**CITY OF SOMERVILLE, MASSACHUSETTS**  
**OFFICE OF STRATEGIC PLANNING & COMMUNITY DEVELOPMENT**  
**JOSEPH A. CURTATONE**  
**MAYOR**

*HISTORIC PRESERVATION COMMISSION*

**ALTERATION TO A HISTORIC PROPERTY STAFF REPORT**

Site: 170 Summer Street, c. 1865 – John Howie House  
Case: HPC 2016.079 Central/Atherton/Spring Summer Local Historic District

King Metal Product    **Item # 45-670**

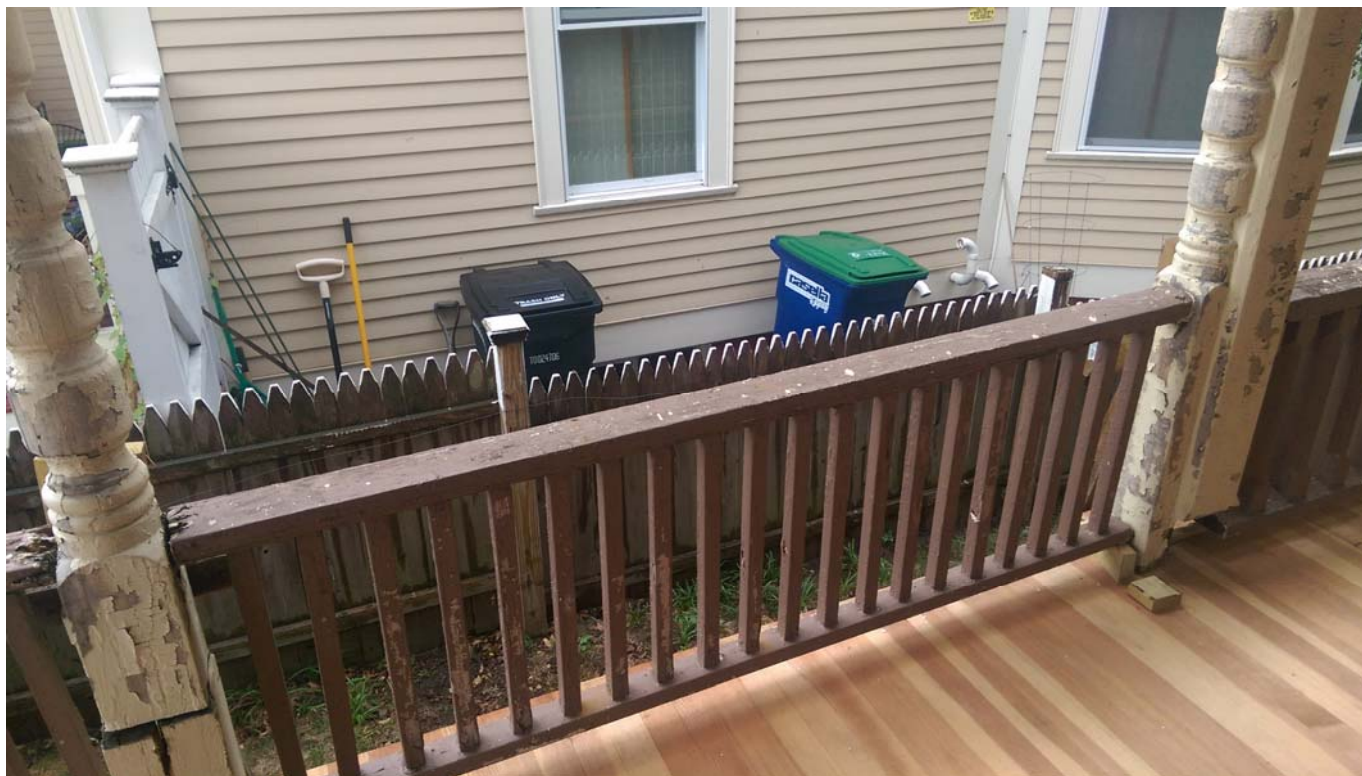
6. Should shingles need to be replaced during the solar panel installation process, the replacement shingles shall be of the same durability, tabbing, profile and color as those currently existing on the roof.
7. An iron fence may be installed and shall have spearhead pickets and a faceted seedpod post top (King Metal Products, Item # 45-670 and related styles and Item # 45-3003-4).
8. The fence shall be an alternating short and tall picket design no higher than 4'.
9. Historic Staff shall issue a sign-off upon completion of the project that it was executed in accordance with this Certificate and approved plans.
